Fantasy Circle Beach Access Improvements

ADDENDUM NO. 3

City of South Padre Island
 Fantasy Circle Beach Access Improvements
 South Padre Island, TX

Date: February 5, 2024

SHEET NO.
S1.5

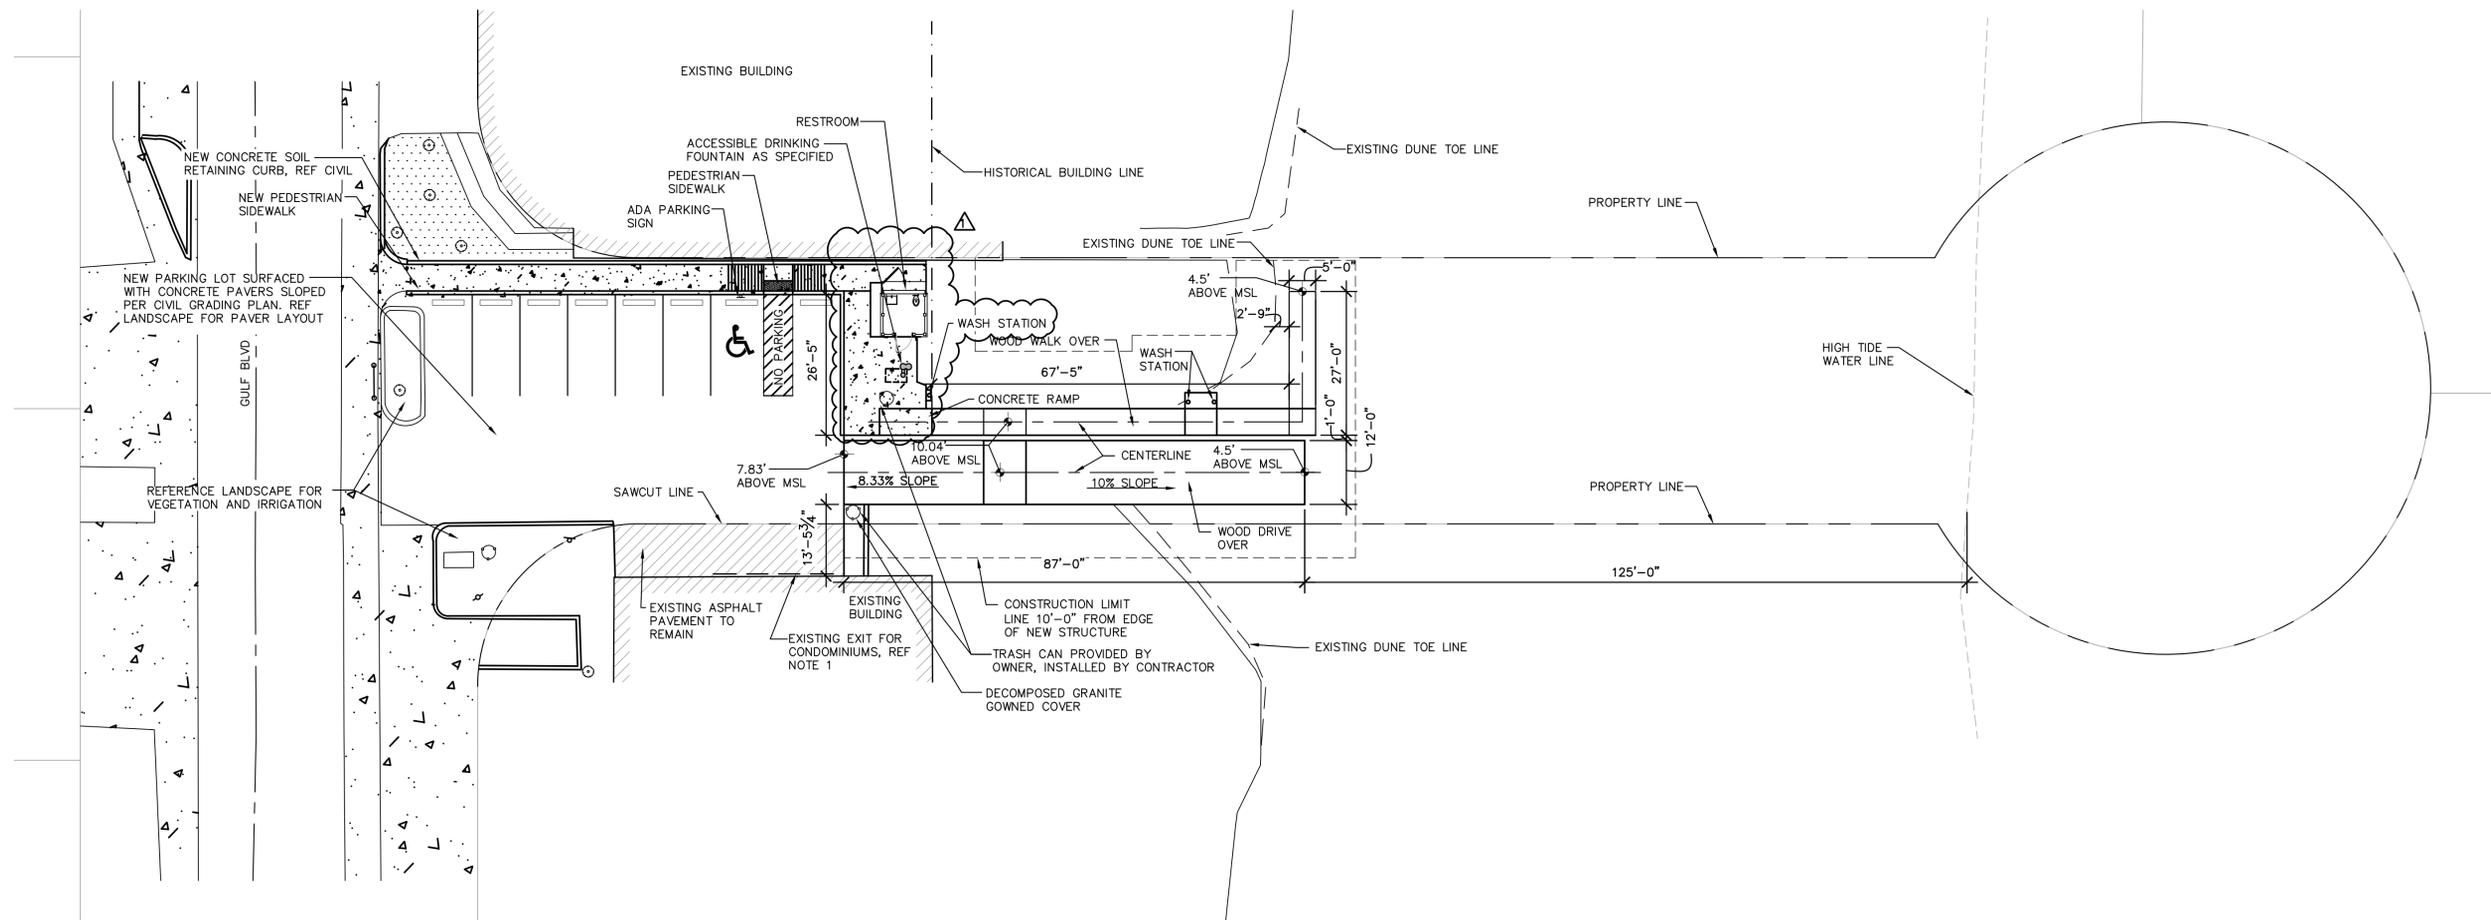
S1.5	Revised Sheet S1.5	Revised Site Plan
S1.5A	Revised Sheet S1.5A	Revised Site Plan
S1.7	Revised Sheet S1.7	Revised Enlarged Site Plan
S2.2	Revised Sheet S2.2	Revised Concrete Walkover Ramp Layout.
S2.6	Revised Sheet S2.6	Revised Detail 5/S2.6
S2.7	Revised Sheet S2.7	Revised Detail 2/S2.7
S2.8	Revised Sheet S2.8	Revised Floor Plan 1/S2.8 & Elevation 3/S2.8
S2.9	Revised Sheet S2.9	Revised Sections 3&4/S2.9
S2.10	Revised Sheet S2.10	Revised Plan detail 1/S2.10
S2.11	Revised Sheet S2.11	Revised S2.11 Revised roof plan S2.11 & ceiling plan 2/S2.11
S2.12	Revised Sheet S2.12	Revised foundation plan 1/S2.12
S2.13	Revised Sheet S2.13	Revised foundation roof framing plan 1/S2.13 & detail 2/S2.13

C1.4

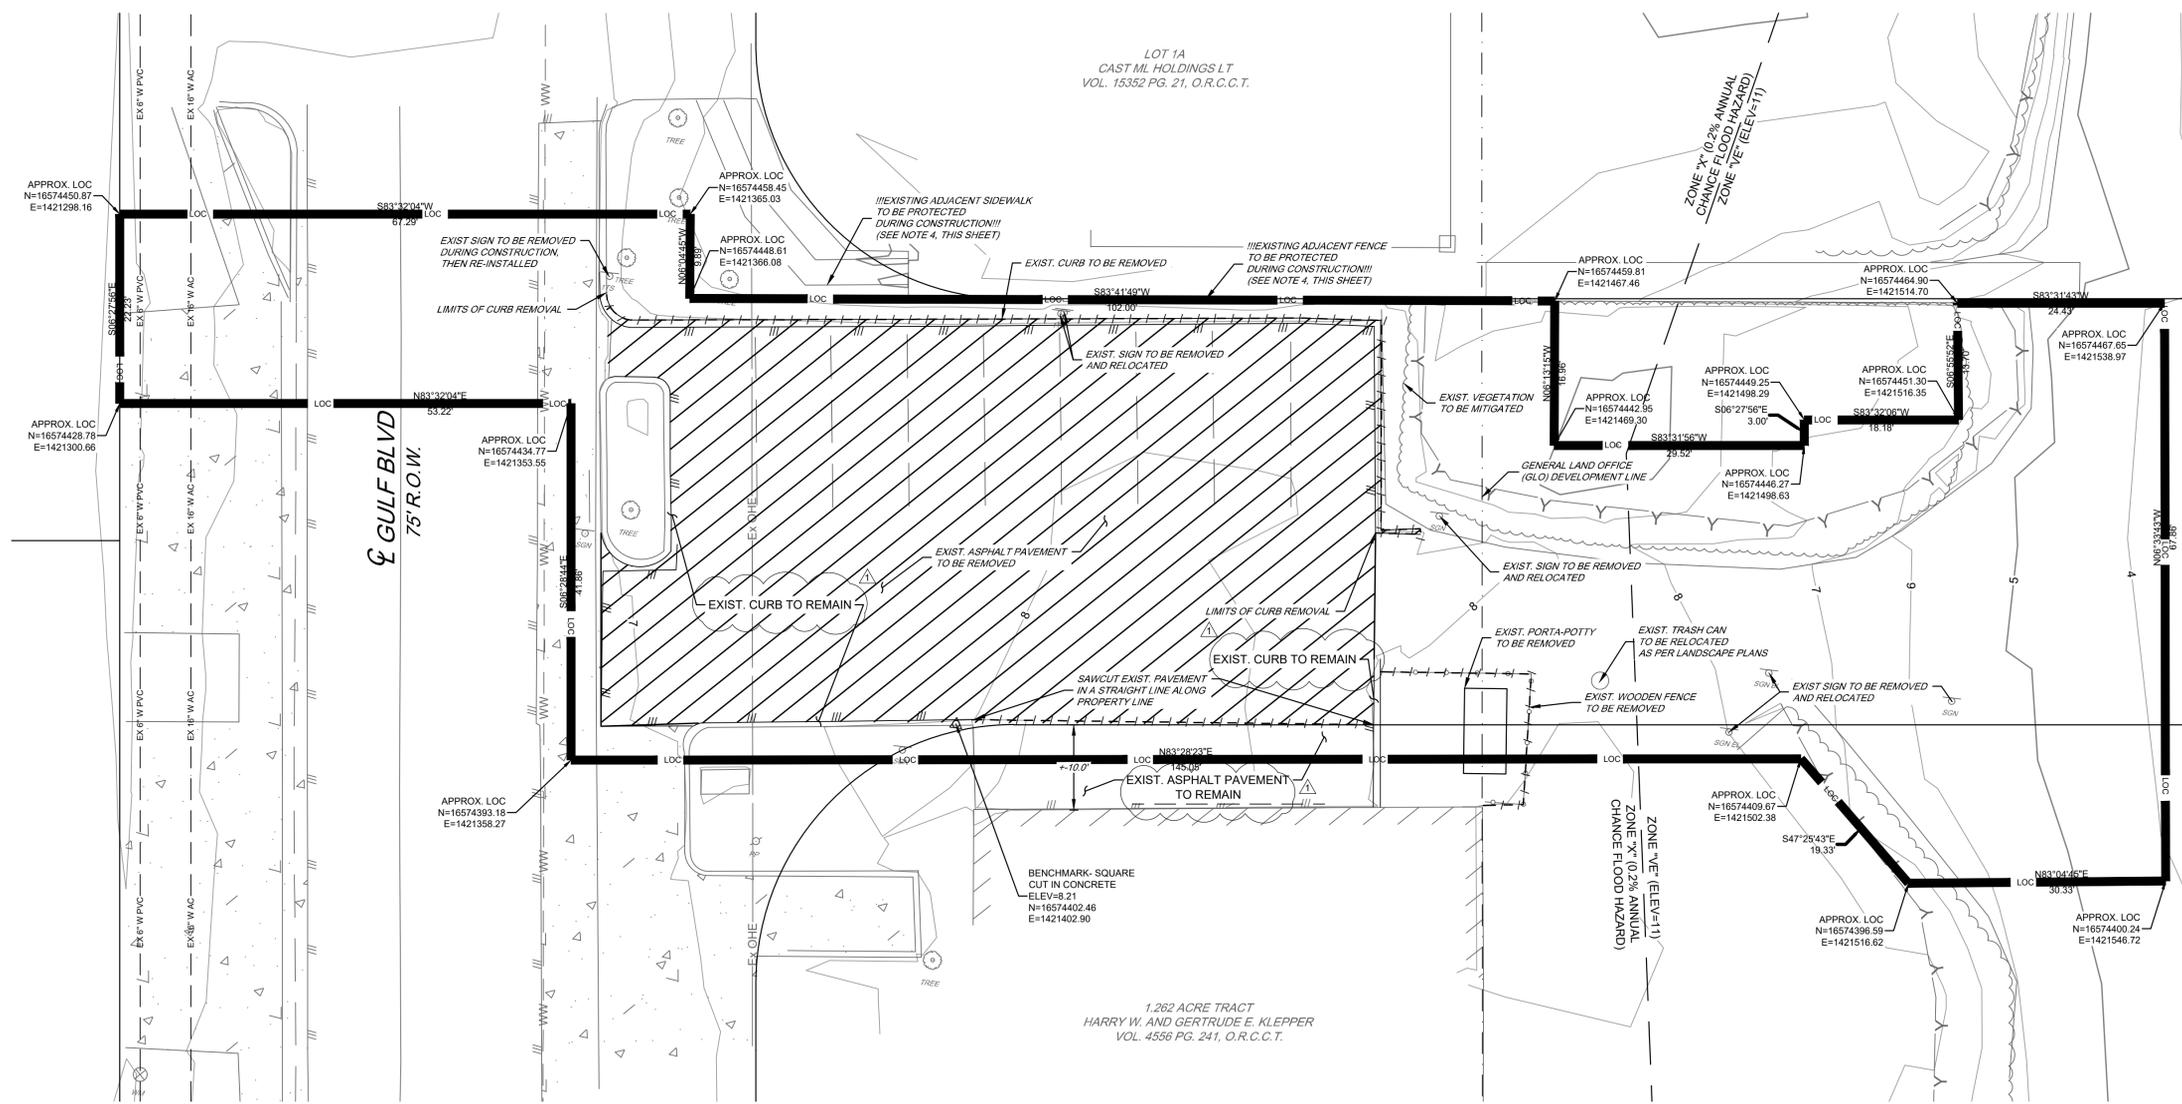
C1.2	Revised Sheet C2	Modified general notes
C1.4	Revised Sheet C1.4	Added callout for existing curb to remain
C1.5	Revised Sheet C1.5	Added callout for proposed ADA accessible parking sign
C1.6	Revised Sheet C1.6	Modified grades of the sidewalks
C1.10	Revised Sheet C1.10	Modified sidewalk details, added expansion construction joint and contraction joint
C1.11	Revised Sheet C1.11	Modified cleanout detail.

SHEET NO.
EP1.01

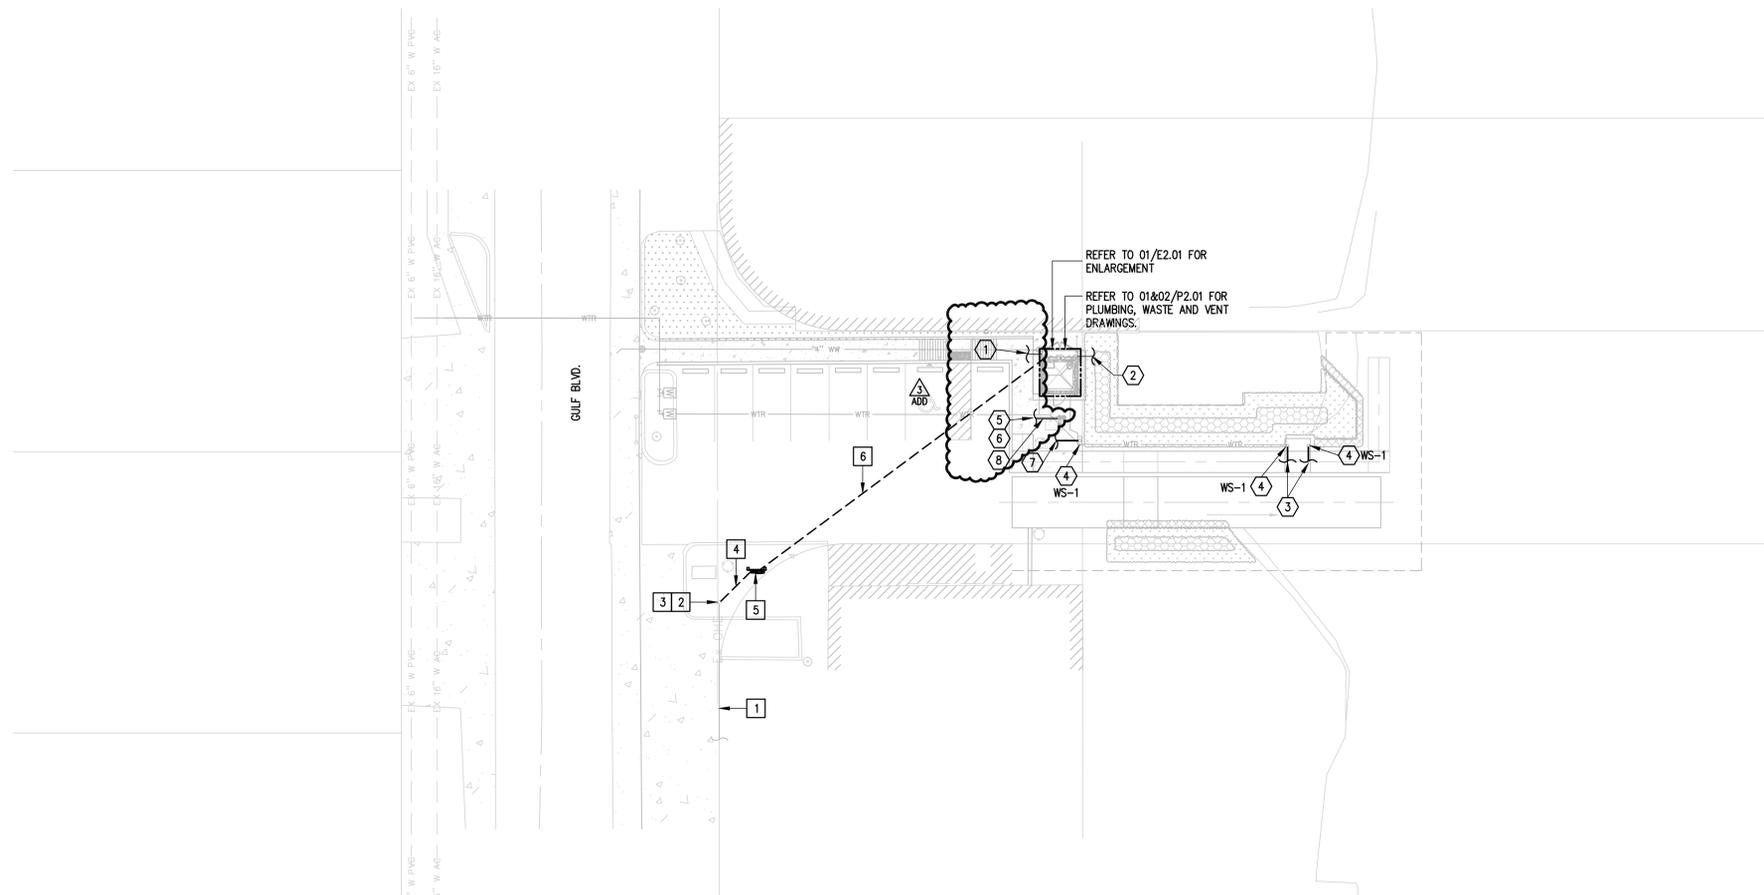
EP1.01	Revised Sheet EP1.01	Revised Electrical and Plumbing Site Plan
P2.01	Revised Sheet P2.01	Revised Restroom Plumbing, Waste, and Vent Plan
3.01	Revised Sheet 3.01	Revised Plumbing Schedules
3.02	Revised Sheet 3.02	Revised Plumbing Fixtures images
